July 2016 Errata Overview

This document provides a redline version of the changes made to the July 7, 2016 City of Tacoma Stormwater Management Manual. Page Numbers used in this document reference the January 7, 2016 Edition.

Figure 3 - 20. Typical Detention Tank

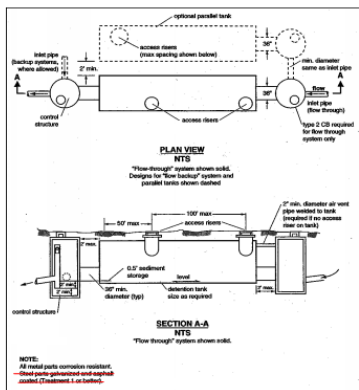
Page 3-86, Figure 3-20

Figure 3 - 21. Detention Tank Access Detail

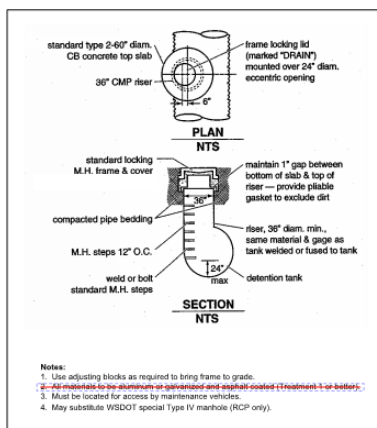
Page 3-87, Figure 3-21

Figure 3-22. Typical Detention Vault

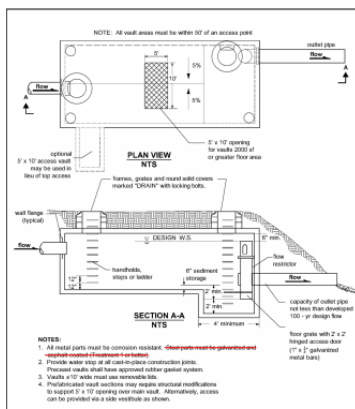
Page 3-90, Figure 3-22
